# UNITED STATES PATENT AND TRADEMARK OFFICE

10/528,342

<b>Office Action Summary</b>	<b>Application No.</b> 10/528,342	<b>Applicant(s)</b> TOLLE ET AL.	
	<b>Examiner</b> NAISHADH N. DESAI	<b>Art Unit</b> 2834

Fig. 5 Ventilation system of the four-circuit IIC motor

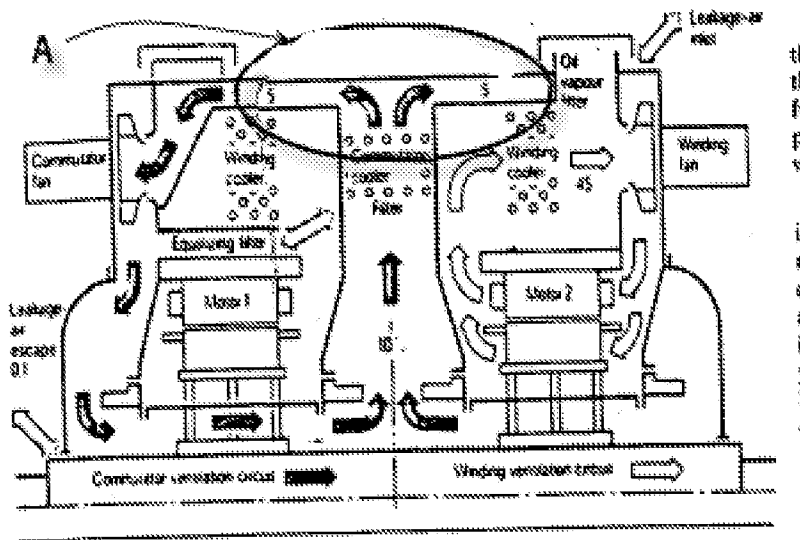
A redundant cooling device for an electric submarine drive motor, comprising (Fig 9 and page 100 Col 3 ll 4-8):

a first cooling circuit and a second cooling circuit, adapted to transport thermal energy away from the electric submarine drive motor, wherein coolant of the first cooling circuit and coolant of the second cooling circuit are adapted to flow in counter current (Fig 9) through a stator cooling ring of the electric submarine drive motor, in a region of the electric submarine drive motor (Fig 9 and Fig 9,A below and page 100 Col 1 ll 1-7).
